# **WATER NEUTRALITY / MAINS SEWAGE REPORT**

This report has been prepared by Plaistow and Ifold Parish Council. It summarises key issues for consideration when assessing the water neutrality and mains sewage implications of application 22/02346/OUT.

#### Issue 6 - Credit for the Water Bank

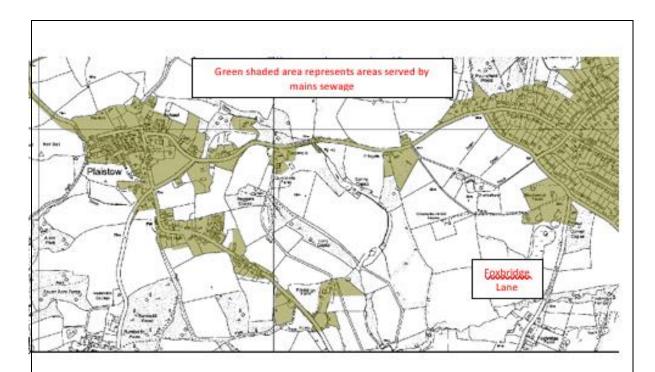
The Quantum CE report V6 makes the following statement in section 4.5, P26:

"theWaterBank will secure the water offsetting credits on its GIS database which will allocate a unique reference number associated to the development site and the schools providing the water credits. Once assigned to a site the water offsets credits cannot be transferred to another site and are secured via a S106 agreed with the Council. theWaterBank can provide a letter of commitment to support this development. Therefore, in order to meet the offsetting requirement, this development would require 5 schools".

Everything in the above statement is future tense and so should not be taken as a credit, i.e., these schools will not currently have made any provision for improved water facilities and/or have committed to the scheme.
